Final Environmental Impact Report
for the

Raley's Landing Project

State Clearinghouse No. 2005042083

January 2006

Source: HOK Architecture 2005 G 05110023.01 015

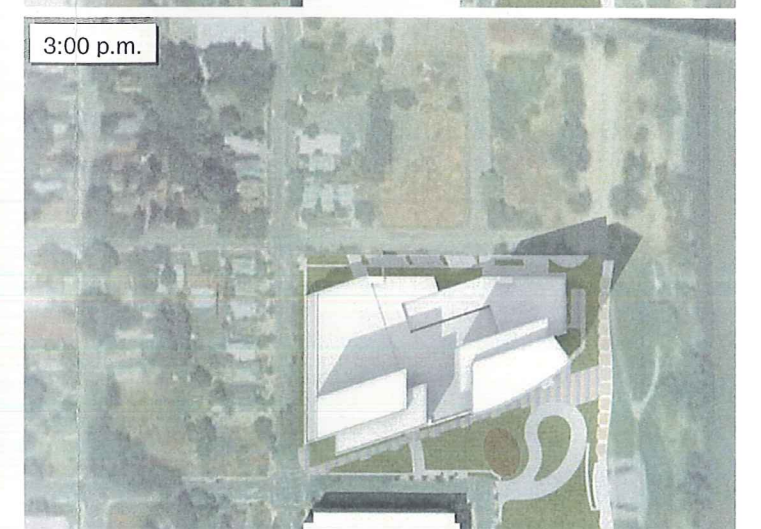
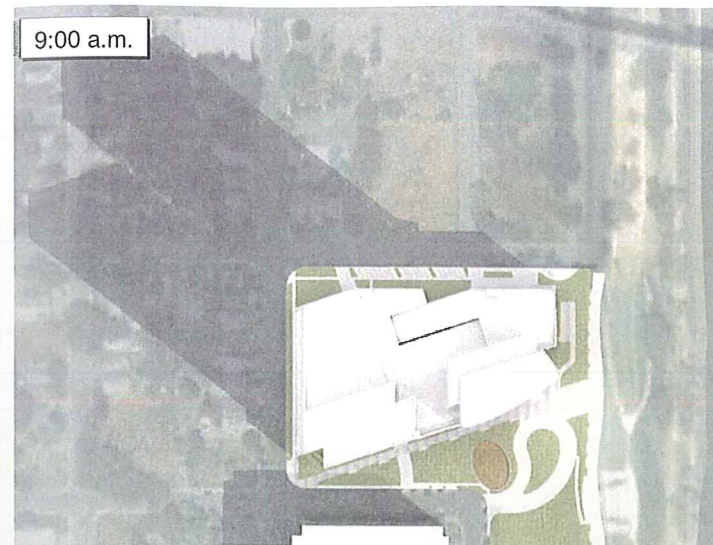
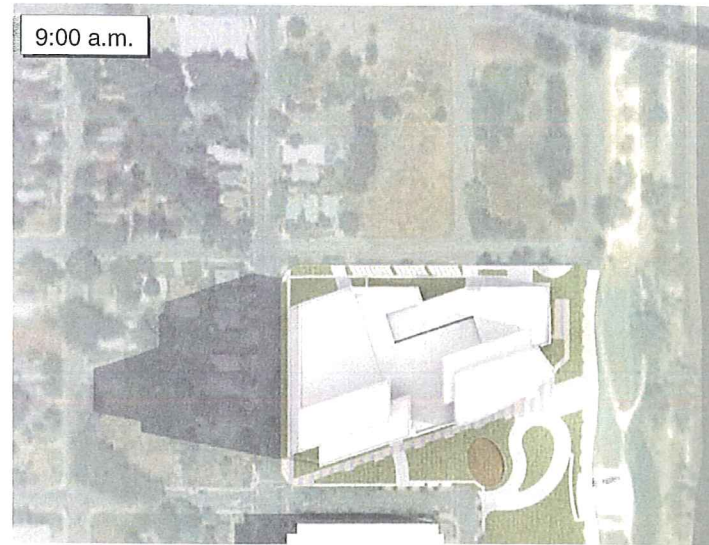
9 One of the impacts I would like to see analyzed a
10 little further, I understand we have decided the traffic
11 is going to be gridlocked here at all considerable times,
12 which I can understand that already. What are the other
13 potential mitigations that maybe haven't been analyzed to
14 a higher degree? That is including better pedestrian
15 access across the I Street Bridge and how would that add
16 into being able to mitigate some of the impacts. A lot of
17 people live here. Most likely work across the river and
18 downtown and/or vice-versa. Those that live in Joe towers
19 might come across this way. Traffic is traffic, and it is
20 one of those things we all realize is going to happen.
21 Ironically, now it is heading up in my direction. But
22 those are the two things that I think aren't necessarily
23 looked at, specifically the shadows cast by the River 3
24 towers and what is the impact on those. I would like to

25 see a drawing on that.

- PH-18 In response to comment PH-18, a shadow simulation for the River 3 area has been prepared and is included in this FEIR as Exhibit 1. As shown in the exhibit, shadows cast by the River 3 development would reach residences to the north only during the winter months. Shadows from the River 3 development would fall on these residences during the morning and during part of the midday hours. As identified in the discussion of Impact 3.12-5, and supported by the shadow simulation, implementing the proposed project would not result in shading of residences along E Street for a substantial portion of the day. Therefore, shading/shadow impacts, as they apply to these residences, are considered less than significant.
